Project	<b>IEEE 802.16 Broadband Wireless Access Working Group</b> < <a href="http://ieee802.org/16">http://ieee802.org/16</a> >	
Title	<b>R-MAC Header Format Enabling Source QoS Control</b>	
Date Submitted	<b>2007-07-05</b>	
Source(s)	Hang Zhang, Peiying Zhu, Mo-Han Fong, Wen Tong, David Steer, Gamini Senarath, G.Q. Wang, Derek Yu, Israfil Bahceci, Robert Sun and Mark Naden Nortel 3500 Carling Avenue Ottawa, Ontario K2H 8E9	Voice: +613-763-1315 E-mail: wentong@nortel.com Voice: +613-765-8983 E-mail: pyzhu@nortel.com
Re:	IEEE 802.16j-07/019: "Call for Technical Comments Regarding IEEE Project 802.16j"	
Abstract	In this contribution, R-MAC PDU format enabling source QoS control is proposed	
Purpose	To incorporate the proposed text into the P802.16j Baseline Document (IEEE 802.16j-06/026r4)	
Notice	<i>This document does not represent the agreed views of the IEEE 802.16 Working Group or any of its subgroups. It represents only the views of the participants listed in the "Source(s)" field above. It is offered as a basis for discussion. It is not binding on the contributor(s), who reserve(s) the right to add, amend or withdraw material contained herein.</i>

# R-MAC Header Format Enabli

Figure xxx. Format of source QoS R-MAC header.

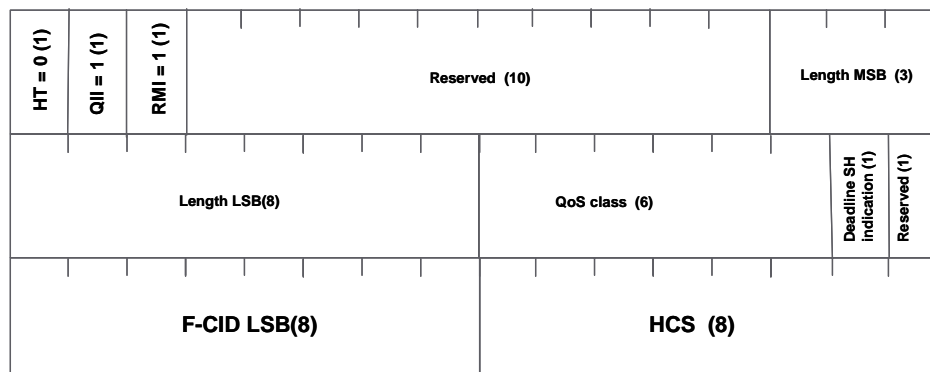
+++++ Start Text +++++  
[\[Add the following section 6.3.2.1.1.1.1\]](#)

[6.3.2.1.1.1.1 Source QoS R-MAC header](#)

The R-MAC header is used always with payload and can be used in both DL and UL. The source QoS R-MAC header shall carry scheduling instruction: QoS class and Deadline SH indication. The deadline sub-header will present if the bit of Deadline indication is set to 1. The format of source QoS R-MAC header is shown in Figure XXX.
